From: [Rodgers, Scott, EMNRD](#)
To: ["Delrae Pima Oil"](#)
Subject: RE: [EXTERNAL] Sampling Plan-NDEV1226 1991 MINOR A INIT @ 0_NDEV1226
Date: Thursday, August 6, 2026 3:37:00 PM

4" GATHERING LINE B 4 9S 35E-LEA

ExxonMobil/XTO Energy
Facility ID: N/A
Lea County
NDEV1226
Site Map

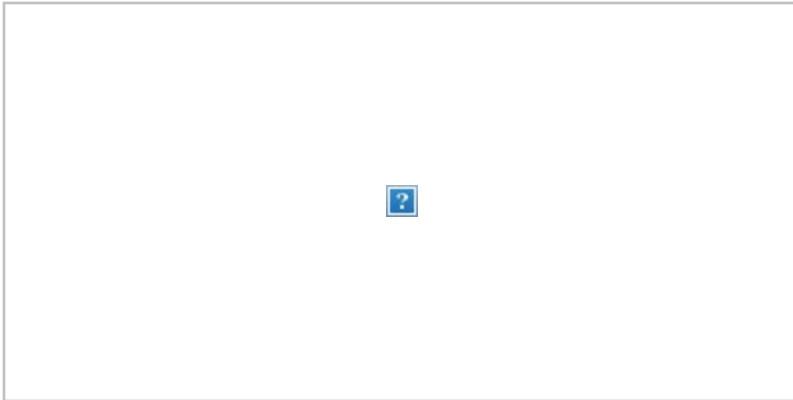
Please review the revised map and see if this looks more accurate. It is partially in unit A, but mostly in Unit B. I don't see anything else in the area that could be it.

This sampling plan is denied. The incident details page for this incident states that the release was from a 4" gathering line in unit B. The current proposed sampling plan shows that samples would be collected from a pipeline ROW in units F,G and J.

The sampling plan is approved.

1. Horizontal delineation must meet the requirements of the reclamation standards 19.15.29.13 NMAC (600 mg/kg Cl, 100 mg/kg TPH, 50 mg/kg BTEX, 10 mg/kg benzene)
2. Soil standards below 4 feet must be delineated/remediated to Table I Closure Criteria for the approved site-specific depth to groundwater. Laboratory data must be provided as evidence of delineation efforts.
3. Please keep a copy of this communication for inclusion within the appropriate reporting documentation.
